Ref: 20C-11-0070-GCO-268448-0

RE: Acoustic Comments – Response to Atkins Acoustics letter (43.6673.L2:GA/DT/2013)

Following our meeting of 24th April at Botany Bay Council and discussions regarding Atkins Acoustics comments on the acoustic report, we hereby provide our response to the points raised in the meeting.

Figure 1: Centre Line of Flight Path – Sydney Airport ANEF 2029

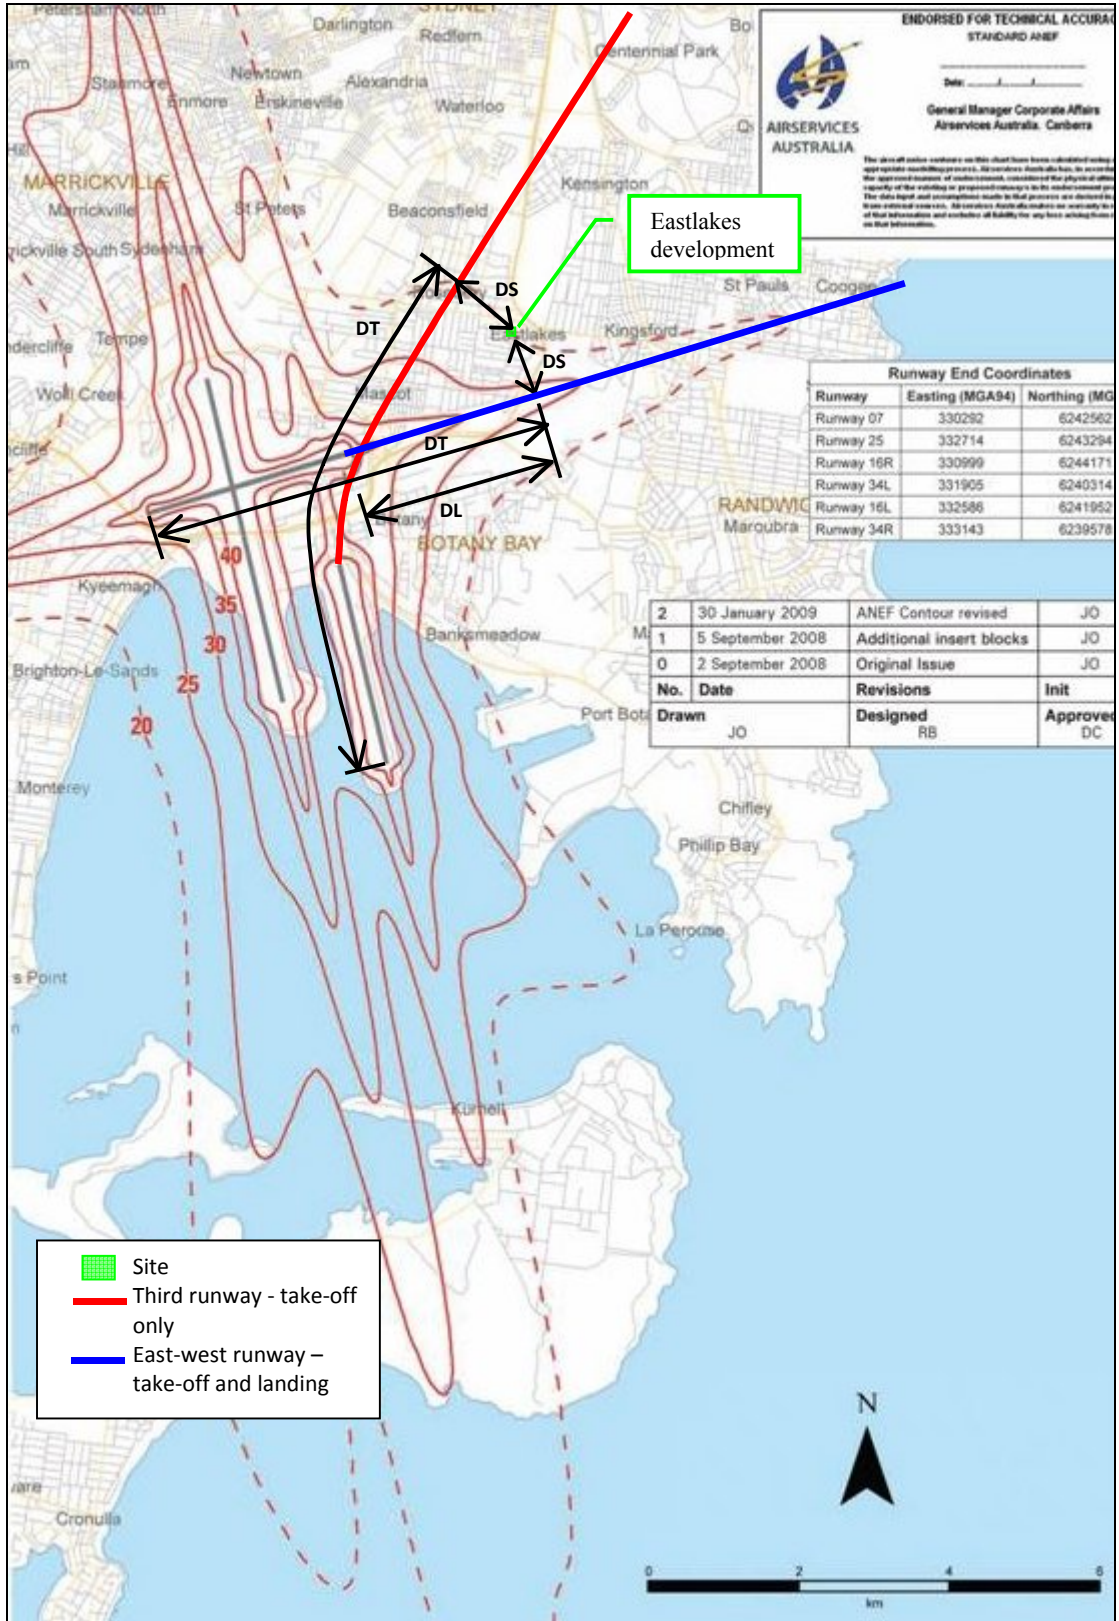
6. *Direct aircraft flyover noise.*

The acoustic report dated 14th February has considered aircraft noise for the East-West and the Third runways.

For the noise impact from the 3rd runway, the peak noise contours as shown on the ANEF curves were used. The application of the AS2021, when determining a curved path uses the centreline of the flight path. Although there may be direct flyovers above the site, the published ANEF contours considers the dispersion of flight tracks about the centreline of the flight path. Accordingly if a direct over flight path assumption were used, this would result in an overly conservative outcome.

The centreline of the curved flight path flight corridor of the Third Runway and of the East-West runway is shown in Figure 1.
